Product Change Notification / RMES-22JKYM836

CCB 4270 Initial Notice: Qualification of GTK as a new assembly site for selected Atmel products available in 28L SOIC (.300in) package.

CCB 4270
Pre and Post Change Summary
PCN#: RMES-22JKYM836

PRE-CHANGE (LPI)

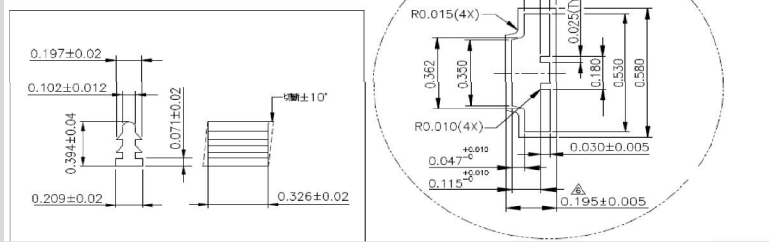
Packing Information (Tube Comparison)

Package	Lead Count	Body Size	Units/Tube	Length (inch)	End Plugs	Package	Lead Count	Body Size	Units/Tube	Length (inch)	End Plugs
SOIC	28	300 mils	27	20+/-0.10	Black/Black	SOIC	28	300 mils	27	20 +/- 0.05	Blue/White
